**NOTICE OF MEETING**  
**PLANNING AND ZONING COMMISSION**  
**6:00 P.M. – August 12, 2021**

PLANNING AND ZONING COMMISSION ITEM:  
PC-21-10  
**Master Development Plan (MDP)**  
Goldsmith Tract

**SUBJECT:** Goldsmith MDP Acceptance  
PC-21-10

PLANNING AND ZONING COMMISSION ITEM:  
PC-21-15  
**Master Development Plan (MDP)**  
**Amendment**  
Belle Oaks Ranch

**MASTER DEVELOPMENT PLAN**  
 FOR  
**THE GOLDSMITH DEVELOPMENT**  
 BULVERDE, TEXAS

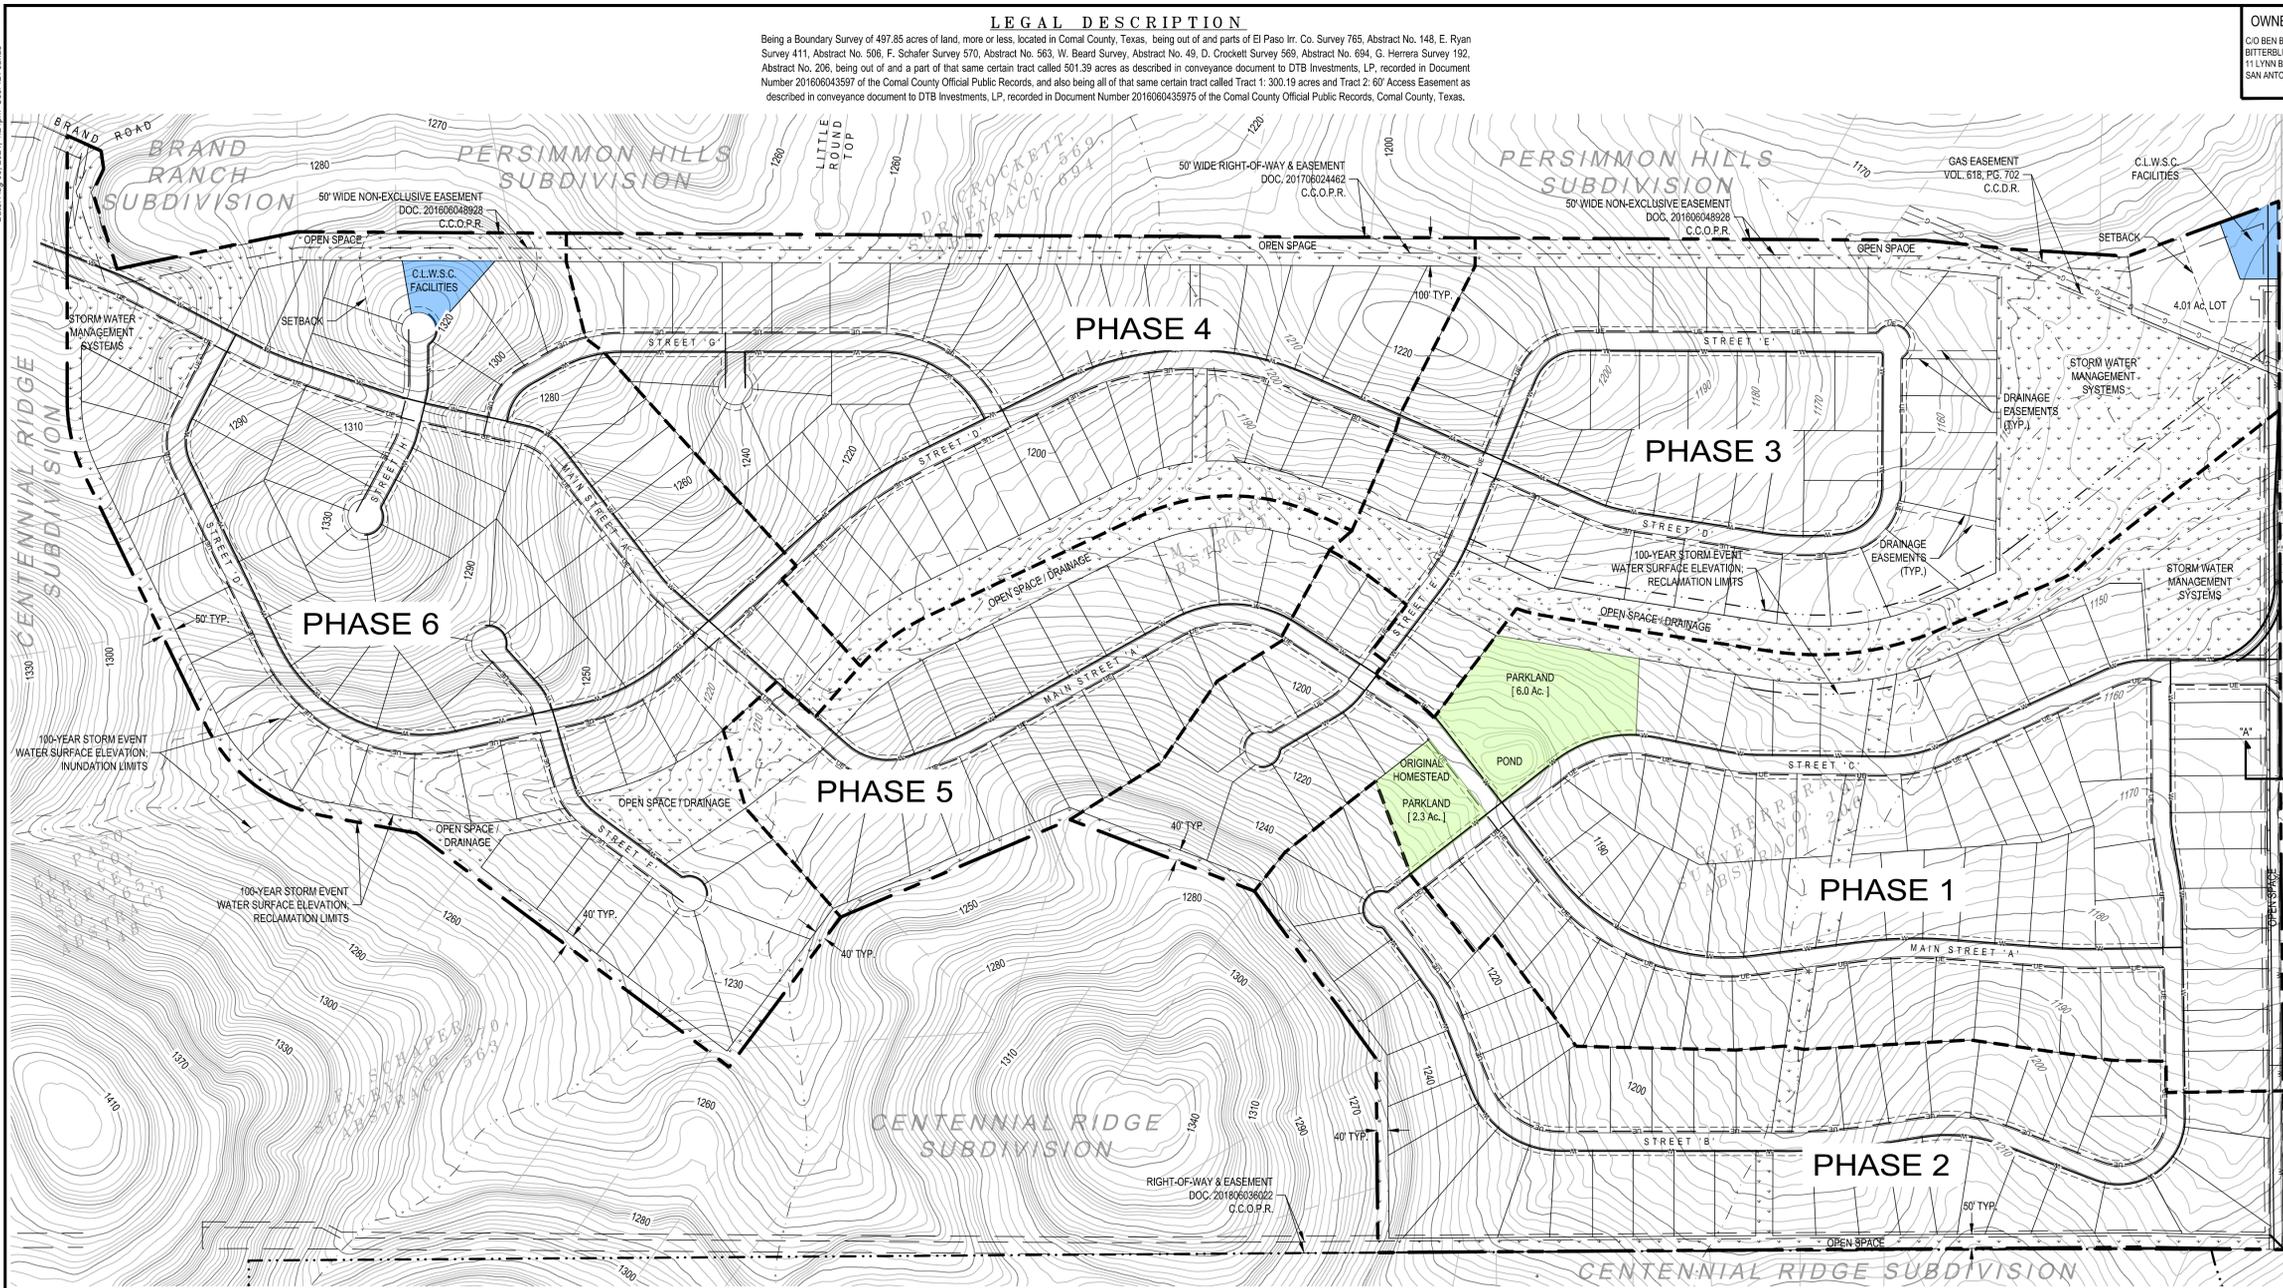
1. Missing proposed lot layouts – [Comment resolved...lots added.](#)
2. Missing proposed utility system layout – [Comment resolved...utility lines added.](#)
3. Drainage: Although a drainage analysis is not required under the vested subdivision ordinance for an MDP, drainage features on the MDP were reviewed. An additional “Storm Water Management System” (i.e. detention) will be needed for the southwest drainage area as shown below. Runoff leaving project boundary must be equal or less than predeveloped conditions. – [See drainage comments for “Downstream Impact Analysis and Drainage Report” dated 6/15/21 at the end of this memo \(not included with original digital submittal\).](#)

5. Goldsmith MDP zoning doesn't comply with current City of Bulverde Zoning Map within city limits. City of Bulverde Zoning Map identifies zoning as R-2 and R-3 within the project limits of Goldsmith MDP. Zoning application will be required. – Comment withdrawn...Development agreement states the lots are to be developed in accordance with R-2 zoning. Confirmed in City staff email 3/3/21.
6. Totals shown in the 'LOT DETAIL TABLE' do not match what is shown in 'LAND USE "R-2" SUMMARY', top right of sheet. – Comment resolved

**REVIEW COMMENT:**  
 Property area, lot count, & density doesn't match what is shown in 'LAND USE "R-2" SUMMARY'.

7. Boundary of development should be indicated with heavy lines. – Comment resolved

1. Per Article III, Section 3 of the First & Second Amendment to the Development Agreement, "Roadways connecting the Property to the Shepherds Ranch Subdivision or to the Persimmon Hill Subdivision are prohibited." A proposed outlet in the Goldsmith MDP appears to connect to Little Round Top which is in the Persimmon Hill Subdivision. – Comment resolved...connection to Persimmon Hill subdivision removed.

**LOS Analysis**

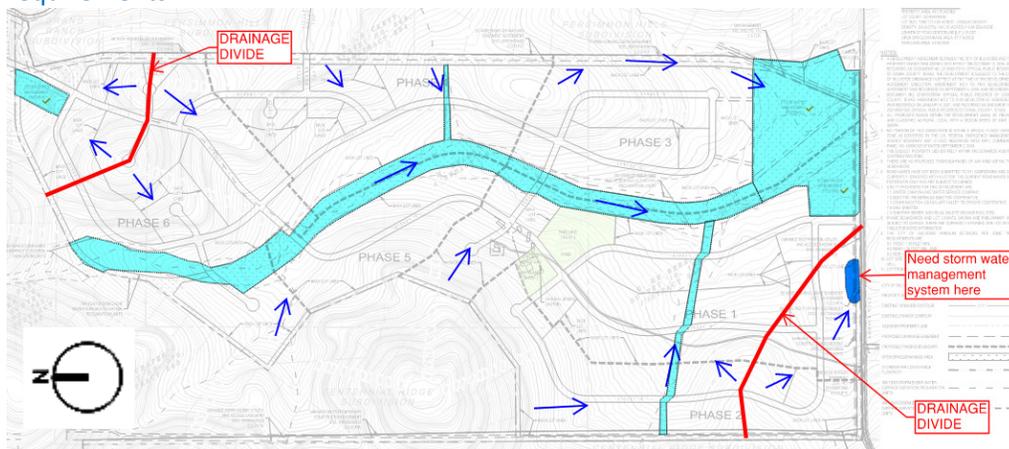
2. Pg. 23, Paragraph 1: One of the sentences notes "As required by TxDOT, a traffic analysis...". This should read "...by the City of Bulverde..." – Comment resolved

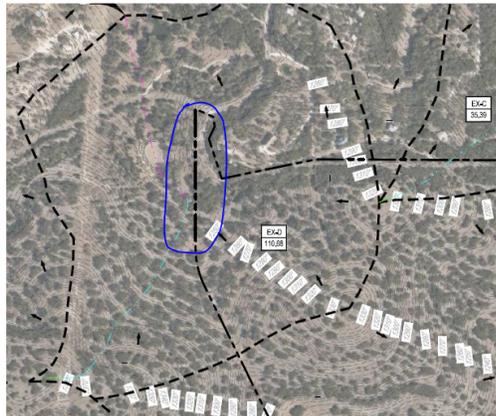
2. A portion of the proposed project site is not incorporated into any delineated drainage area. Please include the portion missing between drainage areas C and D (see yellow highlighted circled area). – [Comment resolved... The new drainage area E covers the previously missing area. No increase in runoff is noted, and no detention is required.](#)

**MASTER DEVELOPMENT PLAN (SHEET 1)**

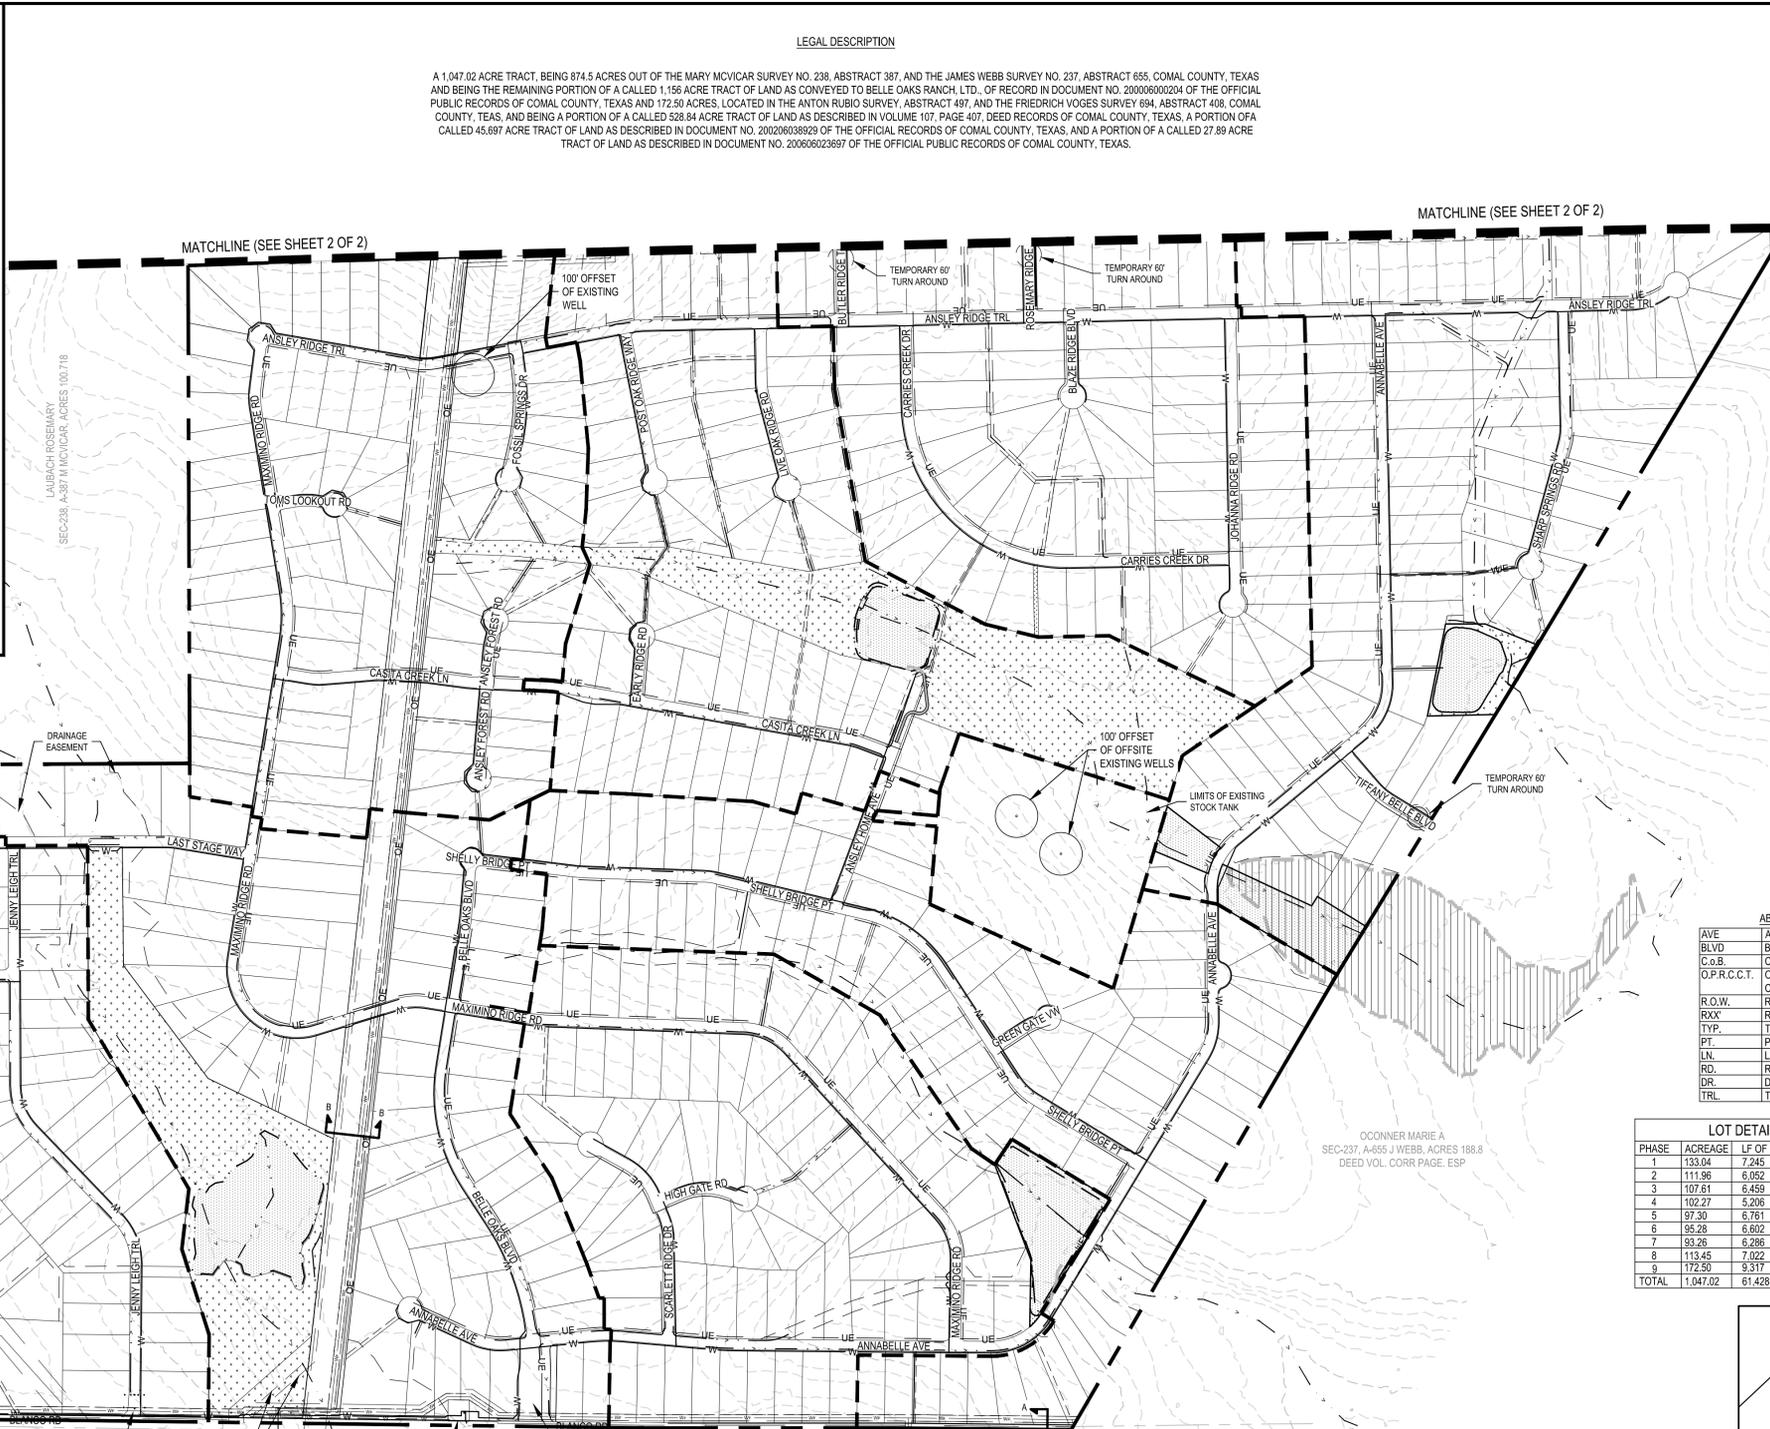
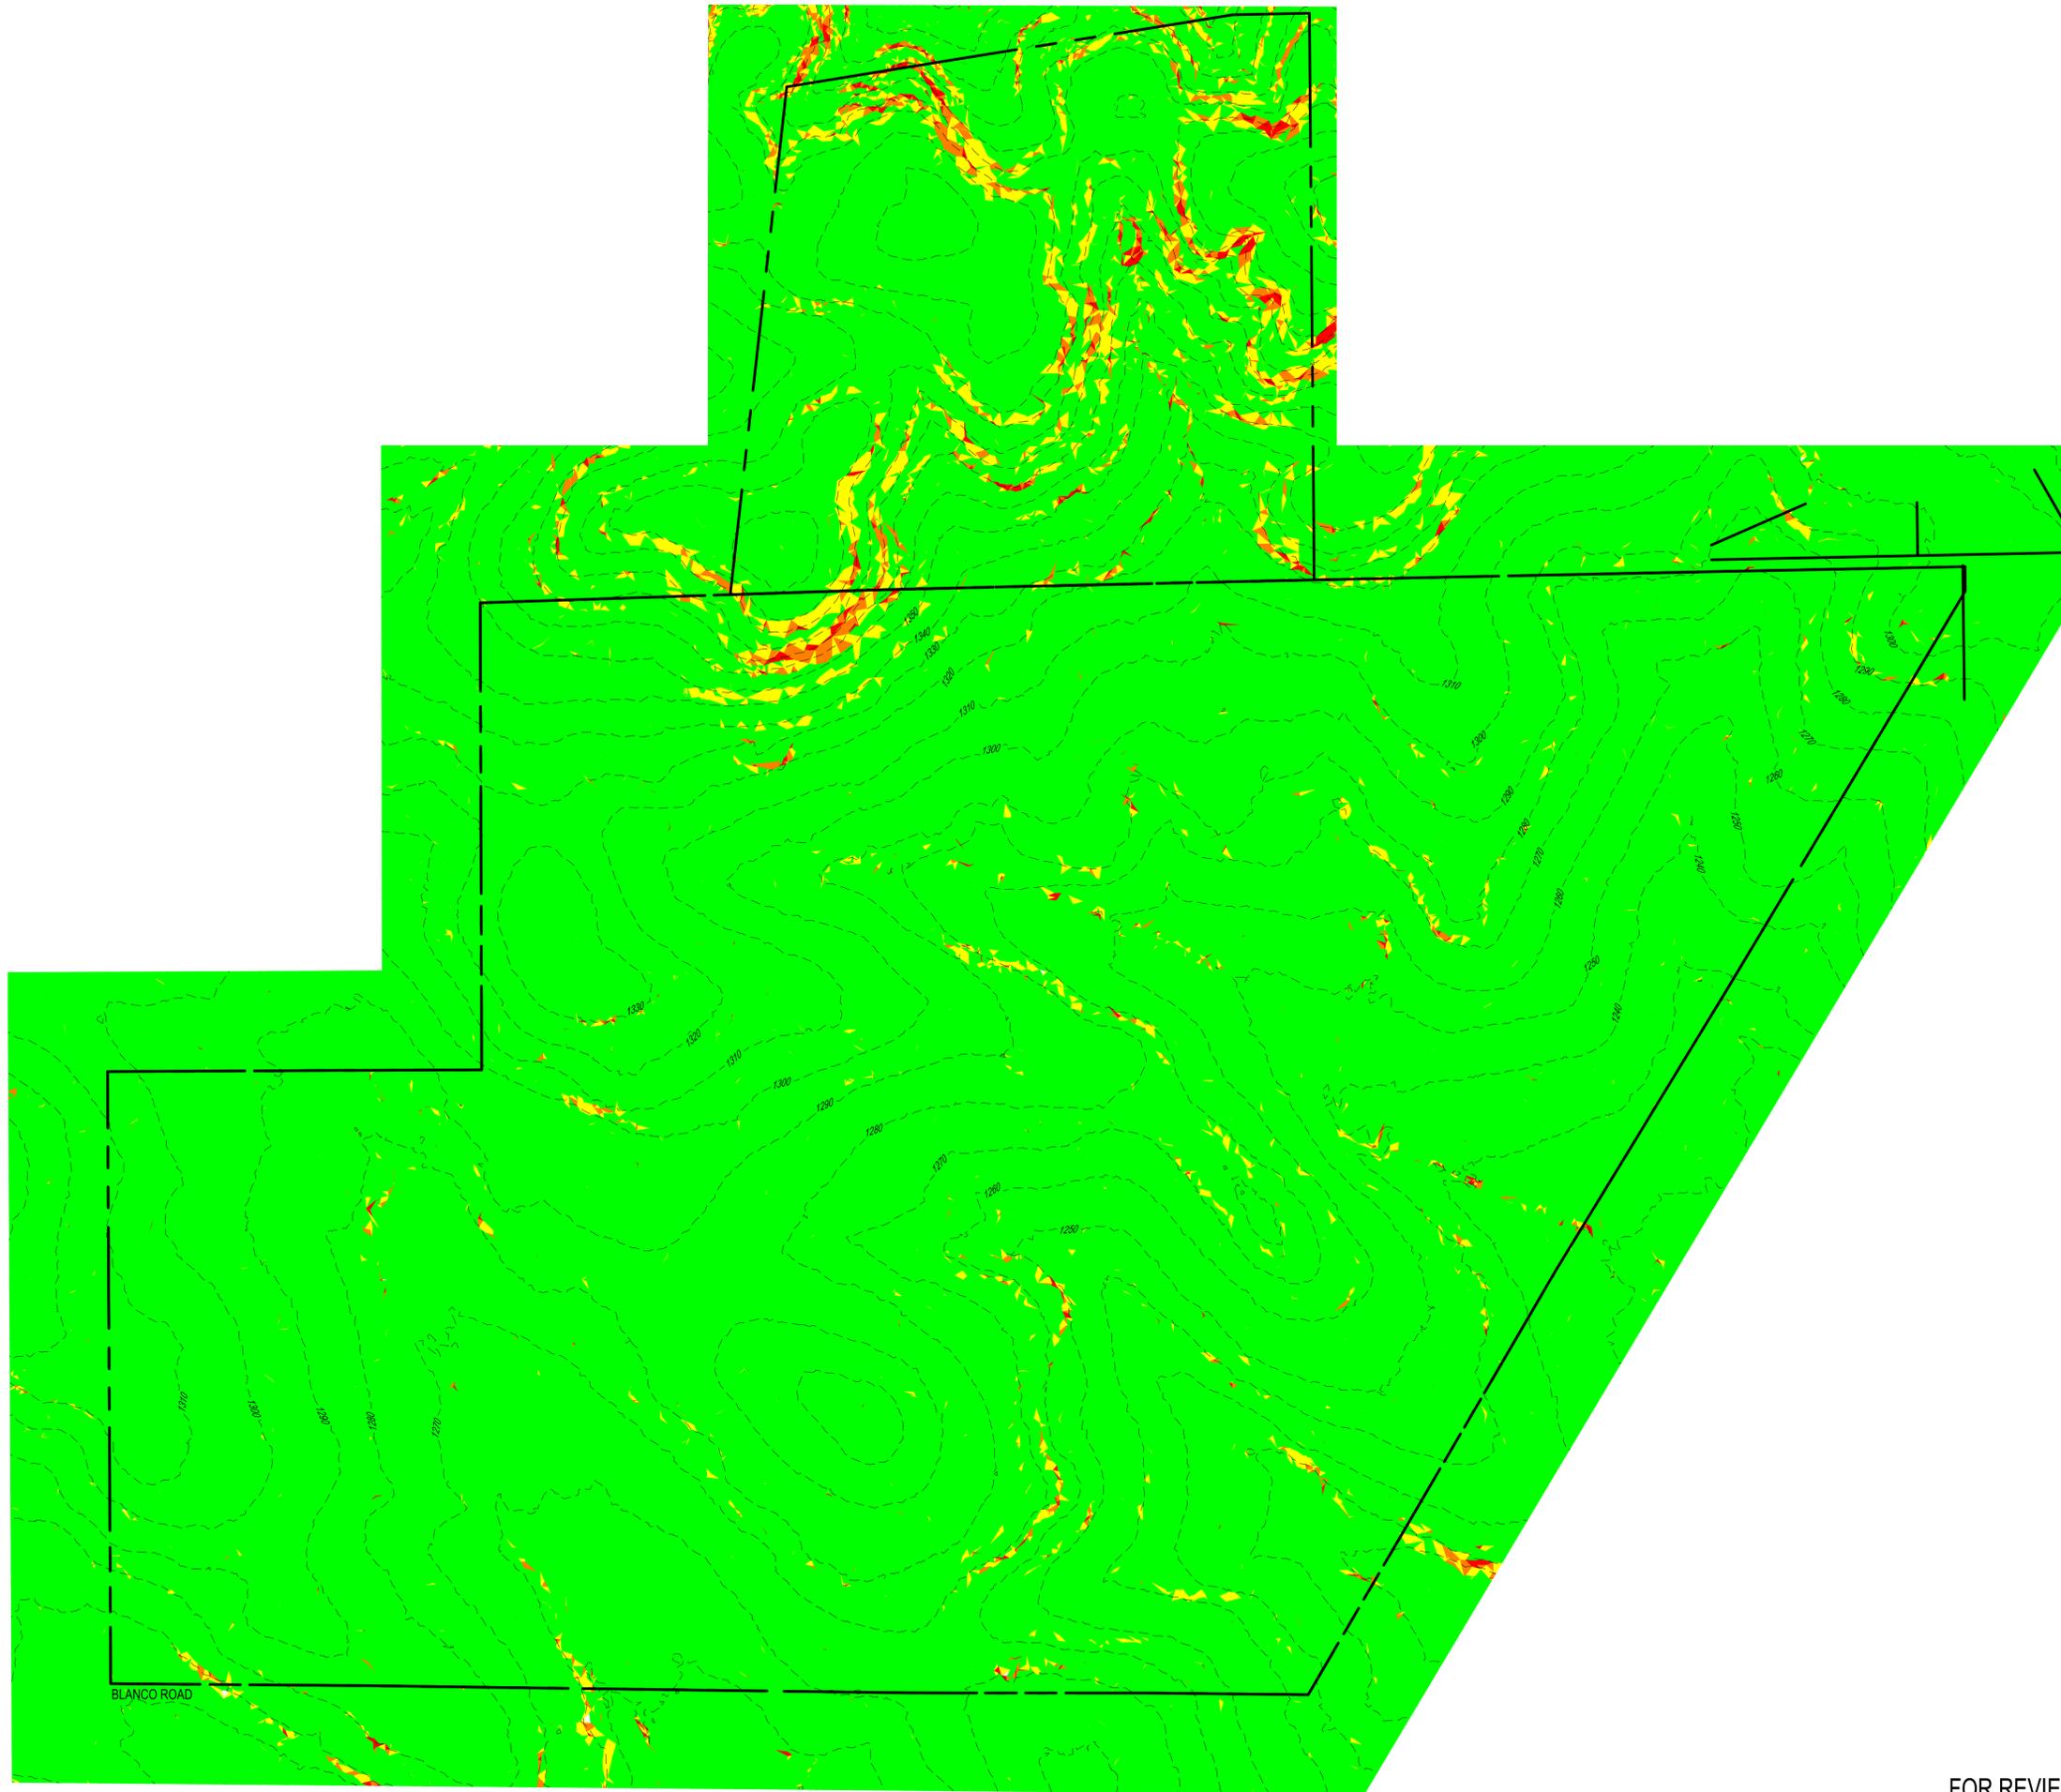
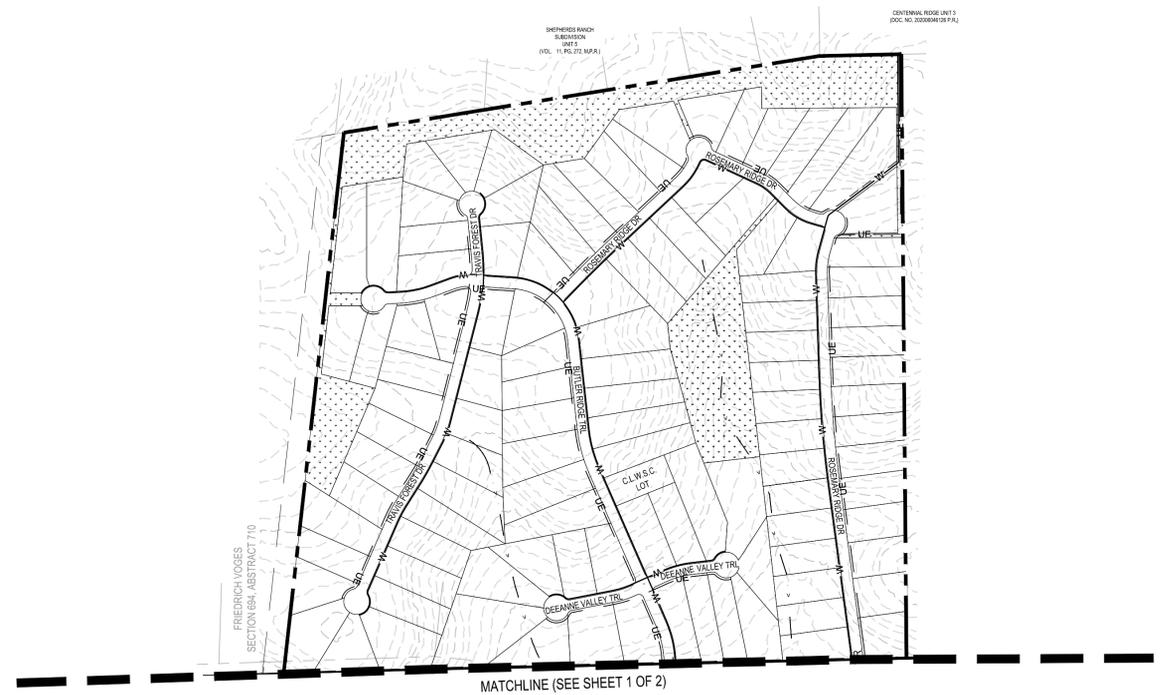
1. Missing tree survey
2. Missing certificate for Enertex natural gas
3. Missing phase ID's on plan map
4. Limits of Existing Stock Tank are missing
5. Missing Detention Pond 1.2 from Phase 4 area. Check all other items from previously approved Master Development Plan, dated 10/15/19. There should not be any differences for Phases 1 through 8 except items that have been approved with detailed design plans (i.e. approximate limits of detention ponds).
